STATE OF UTAH DEPARTMENT OF NATURAL RESOURCES DIVISION OF OIL, GAS AND MINING						FORM 3 AMENDED REPORT <input checked="" type="checkbox"/>				
APPLICATION FOR PERMIT TO DRILL						1. WELL NAME and NUMBER GORDON CREEK SE-30-14-8

BOPE REVIEW GORDON CREEK, LLC GORDON CREEK SE-30-14-8 43007502540000

ON-SITE PREDRILL EVALUATION

Application for Permit to Drill

Casing Schematic

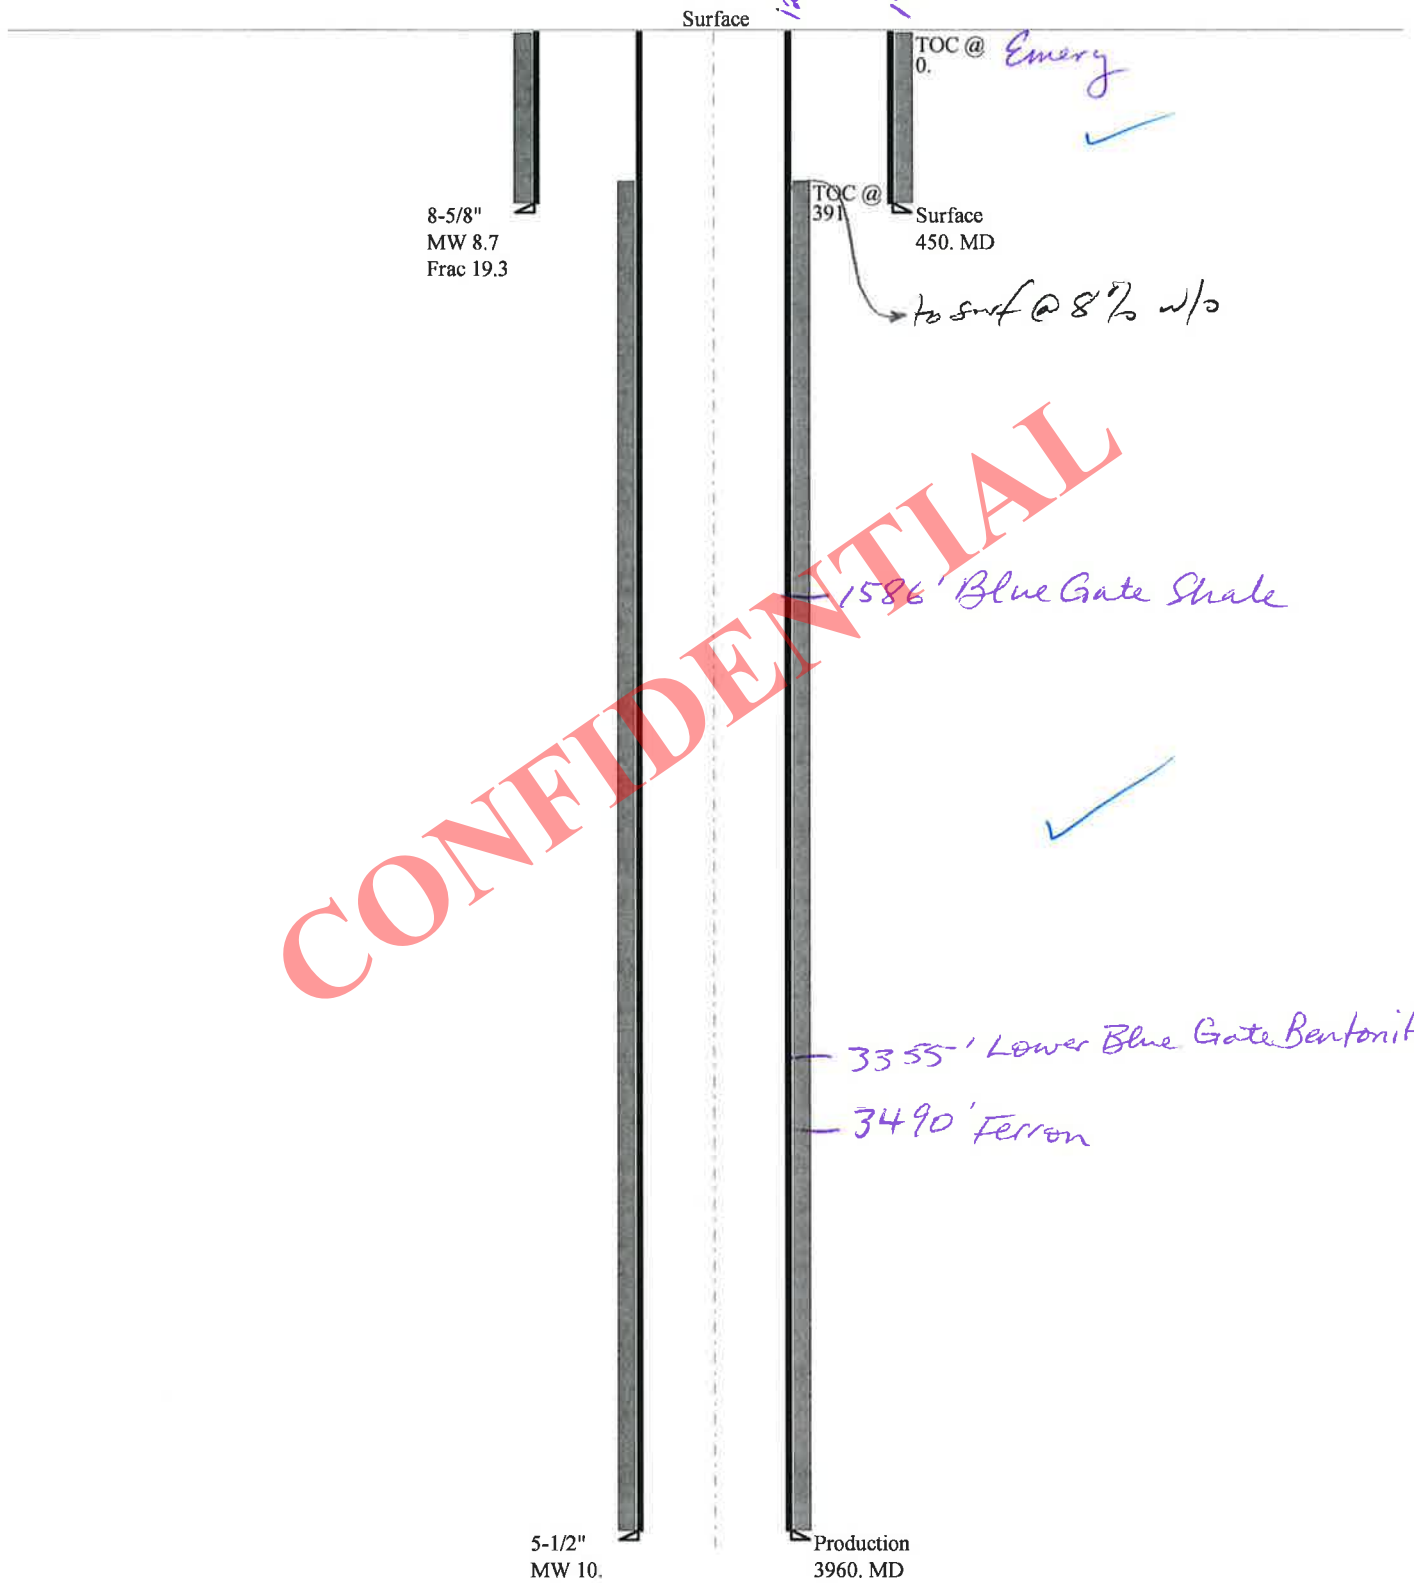
Collapse is based on a vertical depth of 450 ft, a mud weight of 8.7 ppg. The casing is considered to be evacuated for collapse purposes. Collapse strength is based on the Westcott, Dunlop & Kemler method of biaxial correction for tension.

Burst strength is not adjusted for tension.

Collapse is based on a vertical depth of 3960 ft, a mud weight of 10 ppg. The casing is considered to be evacuated for collapse purposes. Collapse strength is based on the Westcott, Dunlop & Kemler method of biaxial correction for tension.

Burst strength is not adjusted for tension.
